Part Number: A054H094					3D image provided when available for visual reference only.	
	Change Notice	CN00114424	Alternates				
	Manufacturer Part (MEP)	No	Usage	Production and Service			
	Release Phase Code	Production (P)	Drawing Specification	Number: A054H094_DET			
	External Regulations	No External Regulation		Revision: G			
Associated Specifications							
Number	Title	Type	Category	Sub-Category			
10903	Substances,Prohibited and Restricted	Engineering Specification	Administrative Specification	Source Control

Drawing Revision Information							
Description of Change(s) Note: Change information is provided for reference only and does not supersede the drawing's primary content.

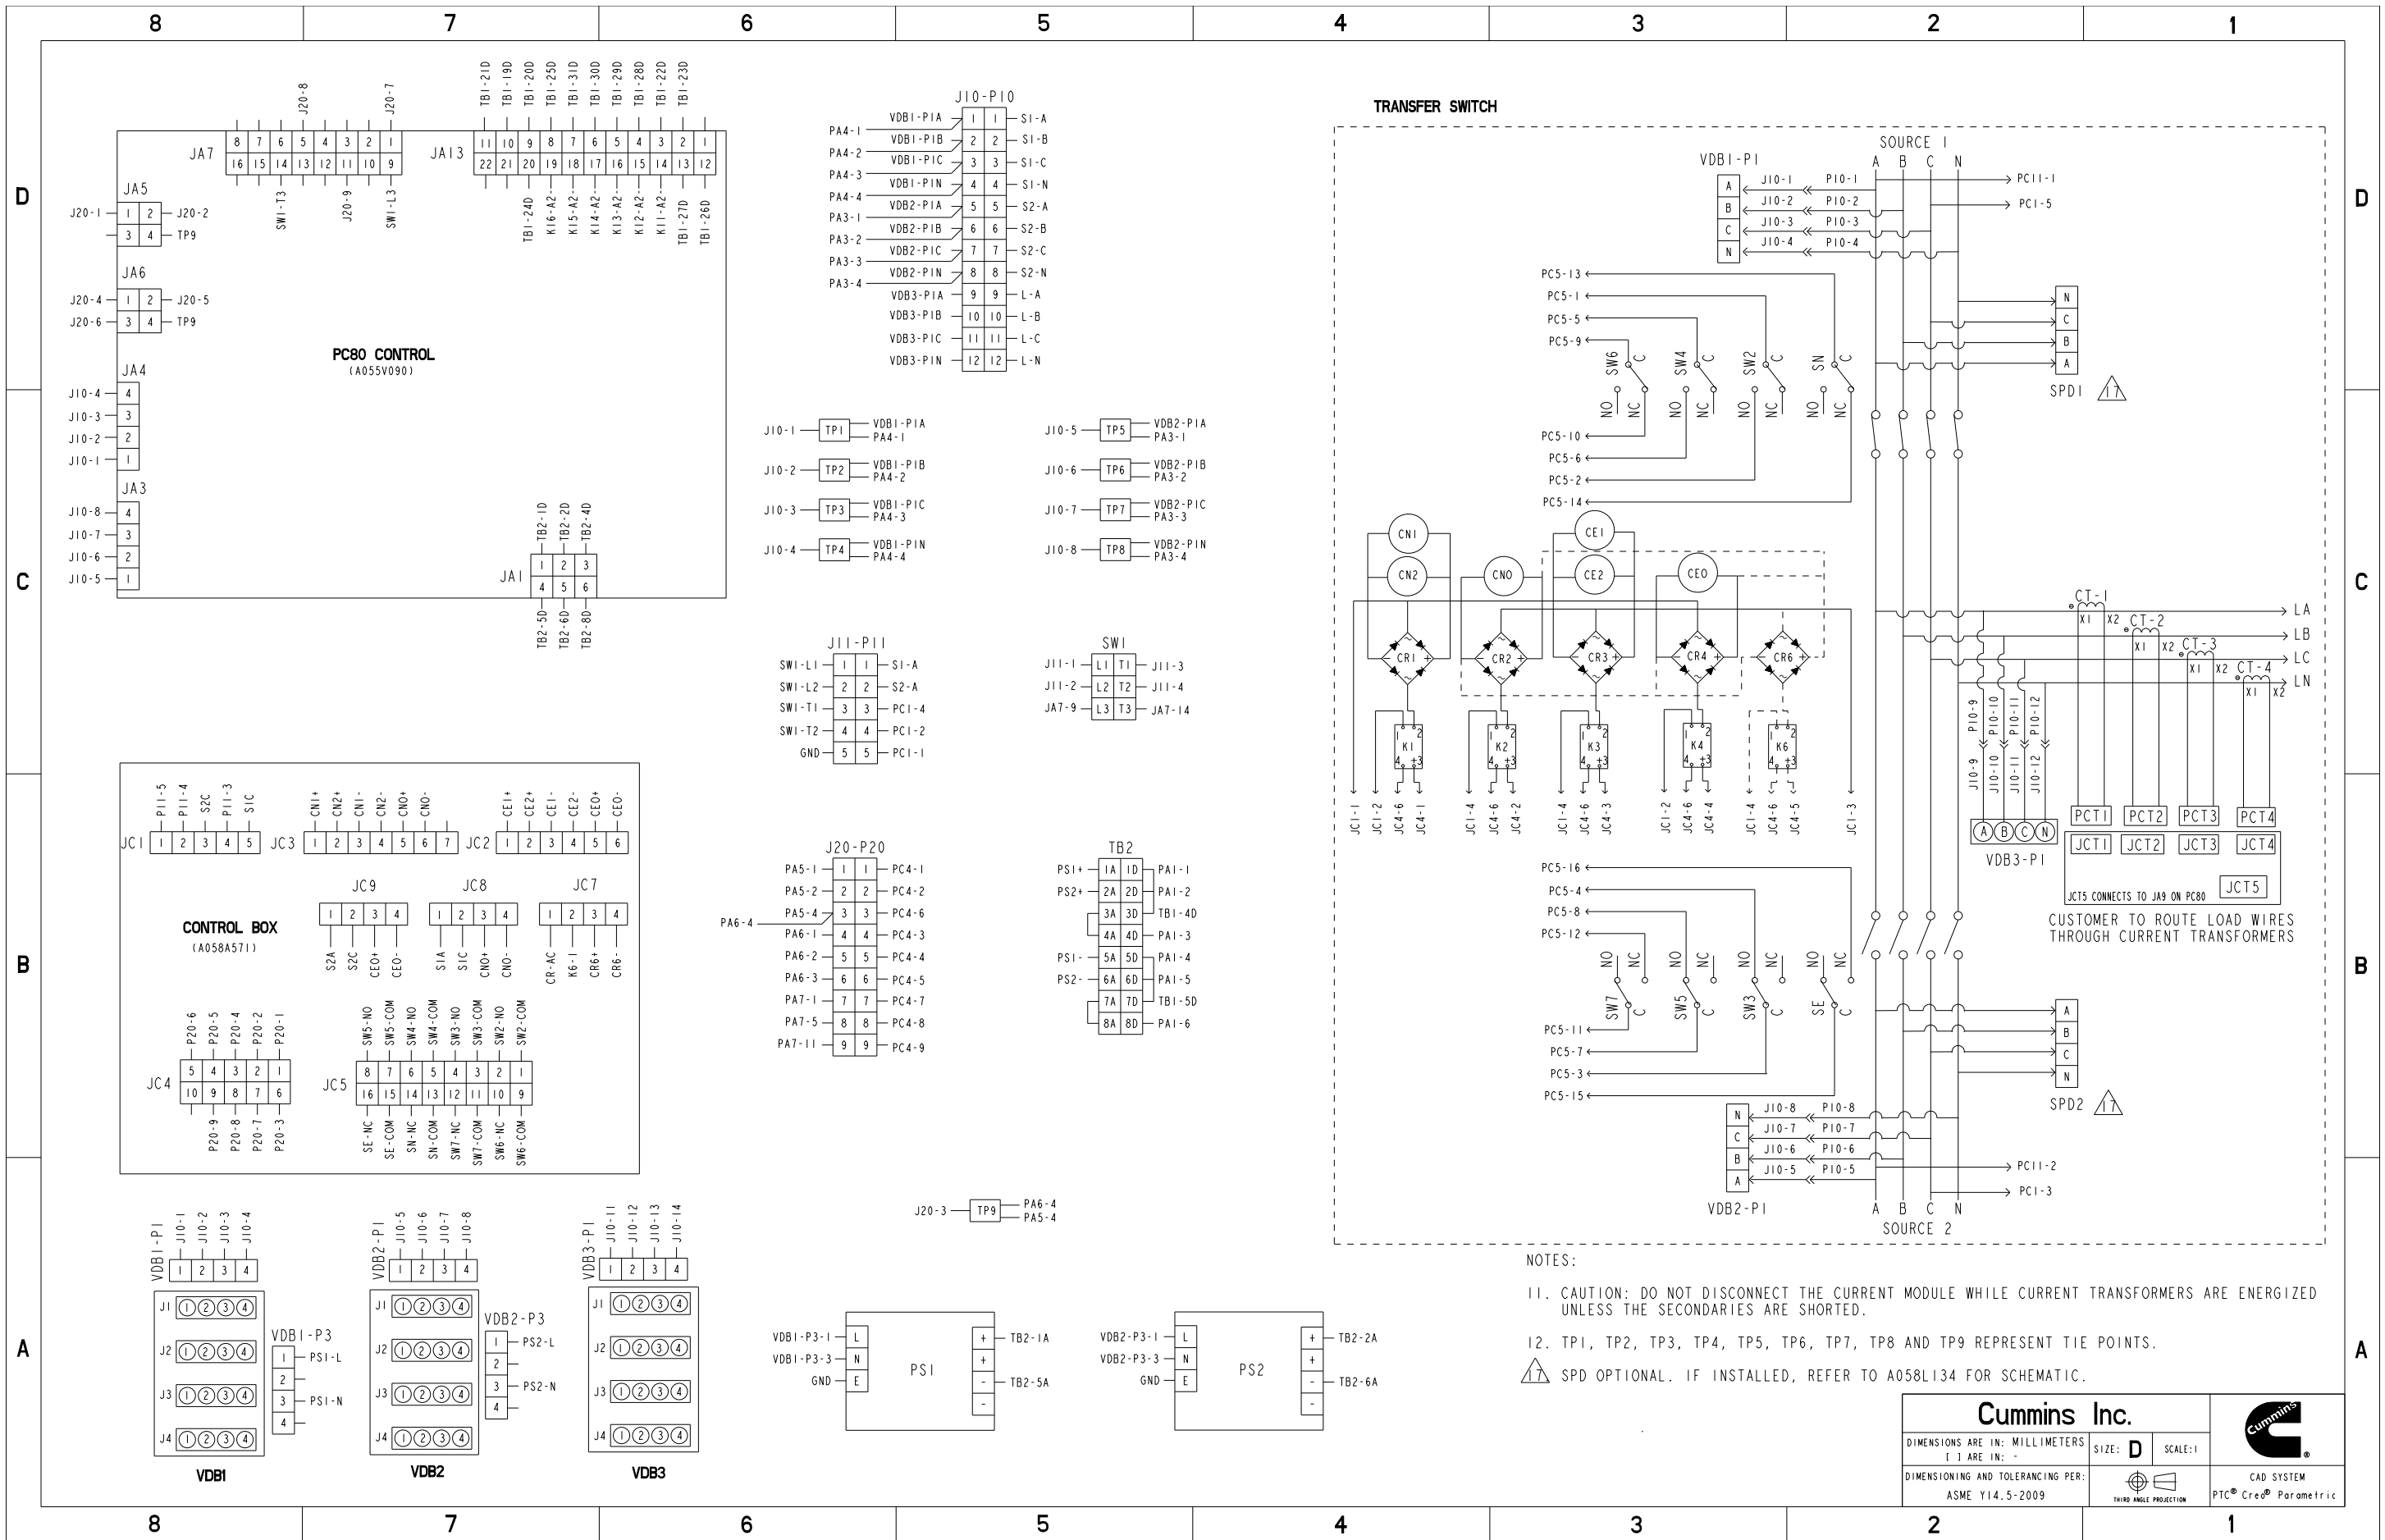
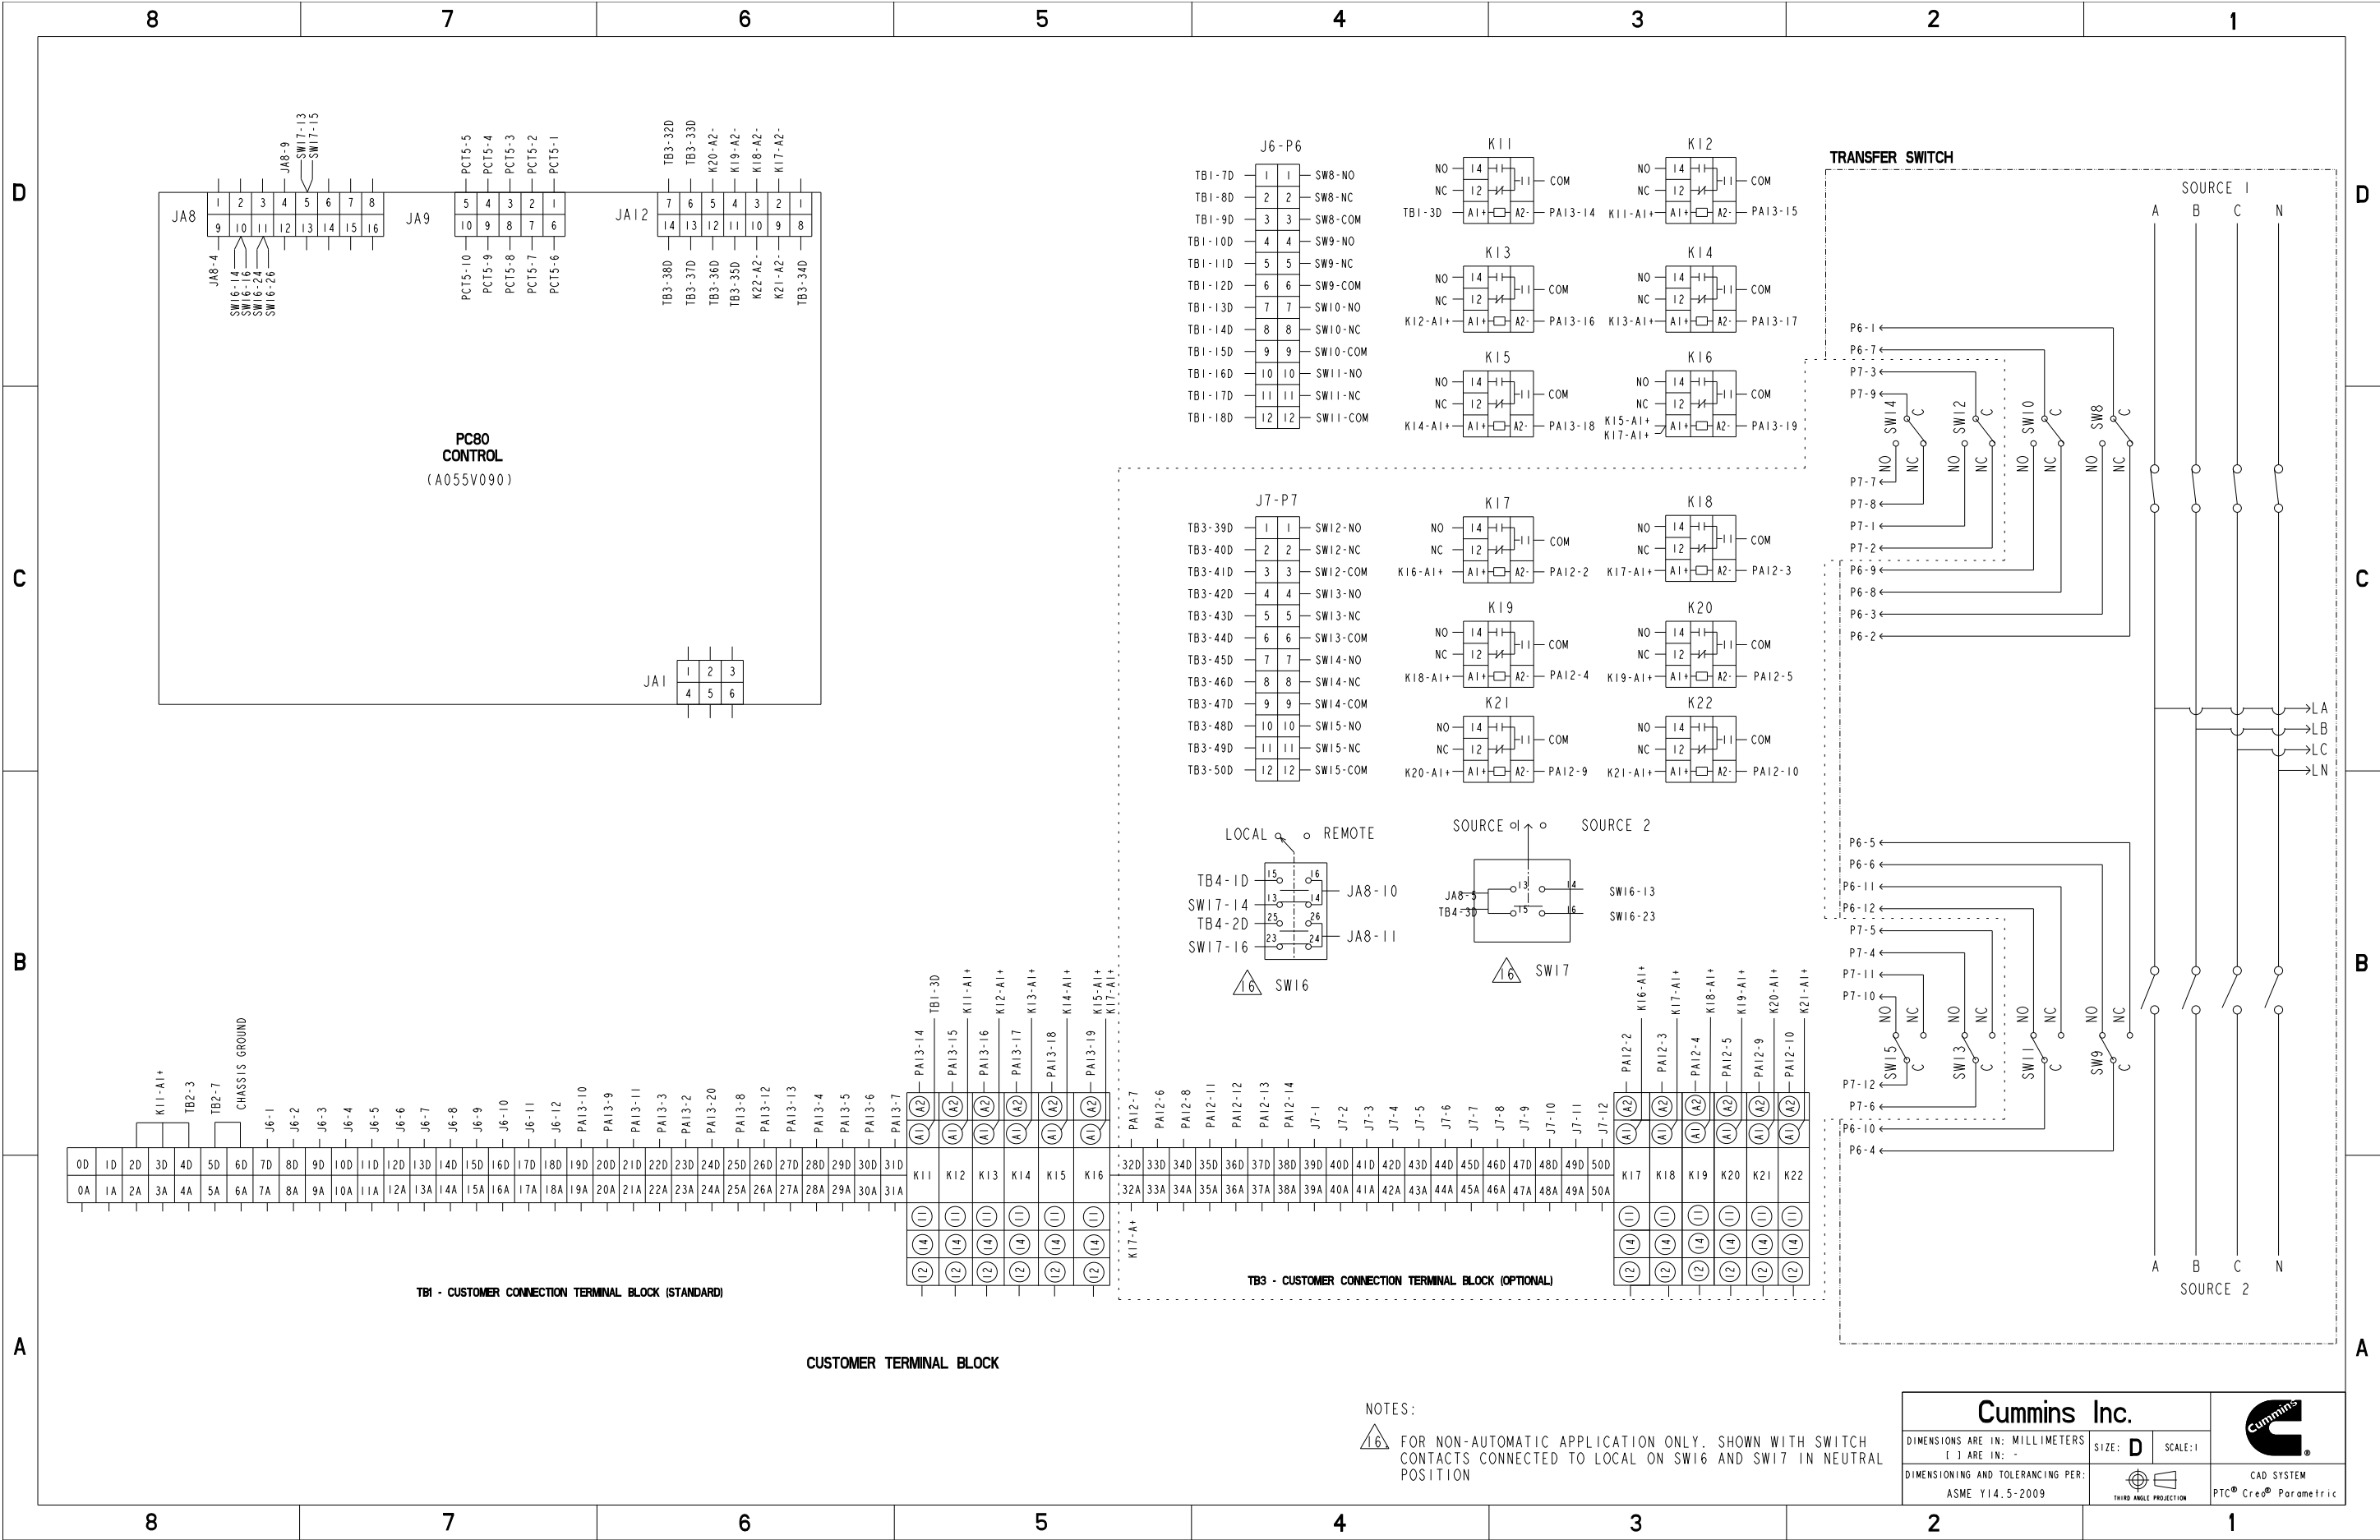
SHEET 1 1. NOTE 16: "SEE SHEET 4" WAS "FOR NON-AUTOMATIC APPLICATION ONLY. SHOWN WITH SWITCH CONTACTS CONNECTED TO LOCAL ON SW16 AND SW17 IN NEUTRAL POSITION?" 2. NOTE 17: "SEE SHEET 3" WAS "SPD OPTIONAL. IF INSTALLED, REFER TO A058L134 FOR SCHEMATIC" 3. NOTE 18: "SEE SHEET 5" WAS "24VDC SWITCH WITH EMBEDDED BLUE INDICATOR LAMP" 4. NOTE 19: "SEE SHEET 5" WAS "EXTERNAL CONTACT BLOCK" 5. NOTE 20: "SEE SHEET 5" WAS "CIRCUIT BREAKER CUSTOMER CONNECTIONS. REPLACE COVER AFTER ANY WIRING CHANGES" 6. NOTE 21: "SEE SHEET 5" WAS "OPTIONAL REMOTE LAMP INDICATOR CONNECTION" SHEET 3 7. ADD NOTE 17 8. ZONE D6: TB1-23D WAS TB1-24D 9. ZONE D7: TB1-24D WAS TB1-23D SHEET 4 10. ADD NOTE 16 11. ZONE B6: PA13-2 WAS PA13-20 12. ZONE B6: PA13-20 WAS PA13-2 SHEET 5 13. ZONE D1: UPDATED ENERGY REDUCTION MAINTENANCE SETTING WIRING CONNECTION 14. ADD NOTES 18 19, 20 AND 21 .
